Title: Relay Frame Structure – comments on 16mRelayFS-AHS - Alvarion

Document Number: C802.16m-08/265

Purpose: Support the comments to the Frame Rapporteur Group output document

Fig. xx Rx operation of RS1

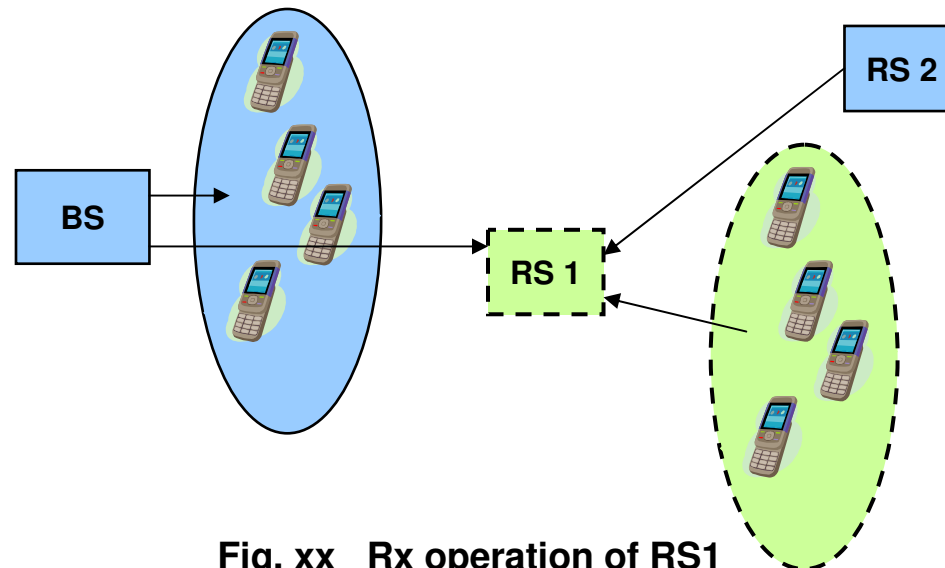
- Multiplexing Access and Relay Links in 16m Zone
 - Usage of UL and DL only is misleading
 - The criteria should be Relay Tx and Relay Rx
 - Better spectral efficiency, flexibility and interference management can be obtained if the multiplexing of 16m Access and Relay operation is done in frequency domain (FDM)
 - The existing text does not reflect 2 hops Relay operation
 - The TDD split creates 6 different Zones in MAC Frame, to be mapped to 6..8 sub-frames (depending on channel width and FFT size), creating a problem of spectral efficiency, resolution of allocations and not leaving time for BS Zones

In the DL 16m zone, inserted in BS DL sub-frame, the traffic is FDM multiplexed in different Zones based on Relay Rx or Tx operation. An example of the BS DL operation and Rx operation of RS1 ((BS->MS, BS->RS1, MS->RS1, RS2->RS1) is given in the next figure.

Fig. xz Relay operation in FDD mode (RS1-Rx, RS2-Tx)

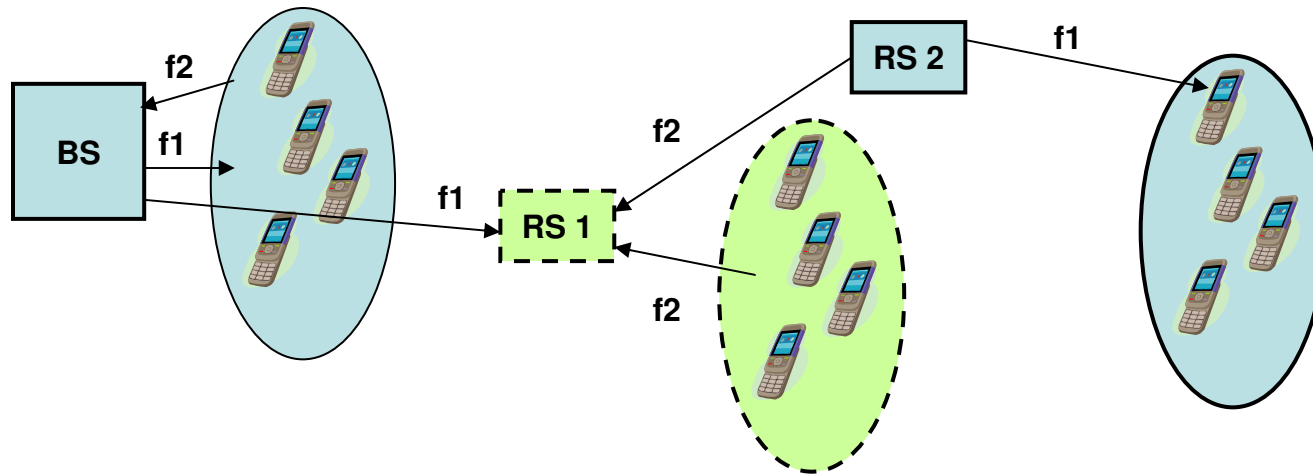
- No text was proposed in 16mRelayFS-AHS
- Alvarion's proposed text (according to principles in C802.16m-08/261):

In the FDD mode the BS DL operation takes place on f_1 and the BS UL operation takes place on f_2 . The legacy BS operation and the 16m BS operation are TDM multiplexed, while respecting the different frequencies used for the BS DL and UL operation.

The RS is the focal point for grouping the Tx and Rx traffic. The following figures show the traffic directions and the used frequencies for two hops, such that each RS will have either Rx or Tx activity.
